RE: Rochester Housing Authority,  
**Parliament Arms Sidewalk and Stoop Replacement**

**ADDENDUM #1**

**Rochester Housing Authority  
Parliament Arms Sidewalk Replacement Project  
HUNT 2285.020**

**ADDENDUM NO. 1**

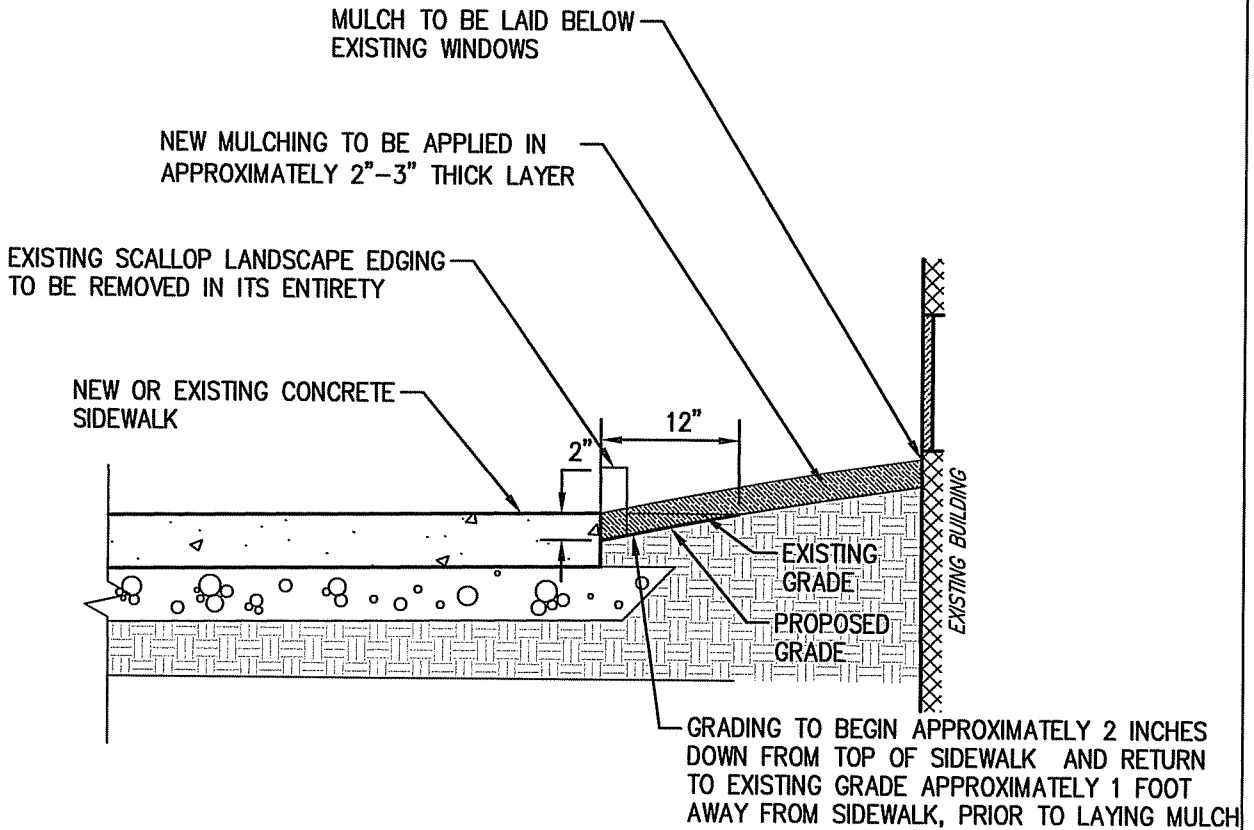
**ITEM AD 1-1 Refer to Drawing L2.0 - "SIDEWALK IMPROVEMENT PLANS"**

**Amend** new entrance drive sidewalk location to be installed approximately one (1) foot from edge of existing entrance drive. New asphalt patching to match existing shall be laid between existing entrance drive new sidewalk as shown on attached drawing AD-L1, issued with this addendum.

1. CONTRACTOR TO BEGIN NEW SIDEWALK APPROXIMATELY 1 FT. FROM EDGE OF EXISTING ENTRANCE DRIVE. AREA BETWEEN NEW SIDEWALK AND EXISTING DRIVE TO BE PATCHED WITH FULL DEPTH ASPHALT PAVING TO MATCH EXISTING
